Technical Service Bulletin								
Date Issued	Model Year(s) Affected		Model(s) Affected		TSB#			
10/19/2006	All Spartan chassis prior		All		265			
10/15/2000	to 4/1/05							
	Brand			Туре				
All	American Star		Mountain Aire		All \square	ТТП		
	Dutch Star		Kountry Aire		FW□	САП		
	Kountry Star		Essex		DP	DB□		
Scottsdale	Northern Star		London Aire			<i>D D</i> D		
☐ Air Conditioning & Heating ☐ Electrical Components								
☐ Appliances & Accessories			☐ Exterior Components					
☐ Cabinets & Furniture			☐ Interior Components					
Chassis Components			☐ Plumbing & Bath Components					
☐ Construction Components			☐ Windows, Awnings, Vents, & Doors					
Description of Problem								
Actual air pressure is lower than the reading on the dash indicator causing the low air pressure warning devices to activate when the air pressure is below the specific range of 60/65 PSI.								
Recommended Solution

Spartan RSB05-400-001 NHTSA Recall No. 05V-146

RSB05-400-001B

SUBJECT: Ametek NGI Air Pressure Dash Indicator Calibration

SIDE VIEW OF AIR SENDERS FIG. 2-1

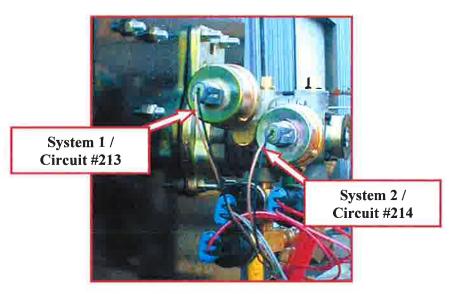
1. Observe all industry safety standards and secure vehicle to allow for disconnection of the air senders at to the front of the treadle assembly.

NOTE: Disconnect ONLY ONE sender at a time to ensure proper reconnection.

FRONT VIEW OF AIR SENDERS FIG. 3-1

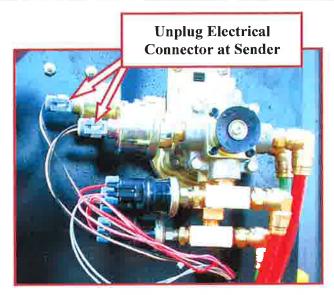
2. Refer to FIG. 3-1. Locate air senders at the front of the treadle assembly mounting plate.

- 3. Unplug electrical connector at one sender, plug one jumper harness from kit into the sender.
- 4. Plug electrical connector (previously unplugged from sender) into the jumper harness.
- 5. Repeat steps #3 and #4 for the remaining sender circuit.
- 6. Test the operation of the air pressure indicator in the dash.
